From: zumman@aol.com
To: ghanisch@crdvco.com; Sandy Vossler
Subject: Master plan - proposed changes to filing 16 parcel 6
Date: Sunday, January 2, 2022 2:19:09 PM

From: [R.C. Hanisch](#)
To: [Adam Brink](#); [Sandy Vossler](#)
Subject: RE: Proposed Site Development Plan Amendment for a portion of Meadows Filing 16, Parcel 6
Date: Thursday, March 24, 2022 11:51:07 AM
Attachments: [The Meadows Filing 16, Parcel 6 Meeting 1 - Presentation.pdf](#)

From: [R.C. Hanisch](#)
To: s.b.wagner@comcast.net
Cc: [Sandy Vossler](#)
Subject: RE: Meadows Filing 16, Parcel 6
Date: Thursday, July 7, 2022 11:55:32 AM

Link and screenshot of traffic count is below...

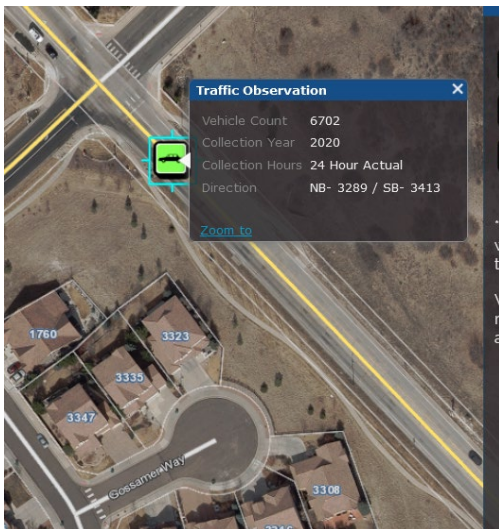
I spoke up in the neighborhood meeting on Monday 1/10 with concerns about traffic on Coachline (in particular between Wolfensburger and Foothills). I cited that according to the interactive CR traffic count map there were 6702 vehicles recorded in 2020 over 24 hours. This could be delivery vehicles, people going to and from work, people crossing from one road to another, using the open space, etc. My guess is that number has grown.

What steps can be taken to mitigate traffic to increase the level of safety for all? More roundabouts? Lower speed limits? Speed bumps? Traffic lights? Please consider my concerns and review possible solutions to throttle traffic in a more effective, safer way before it gets worse.
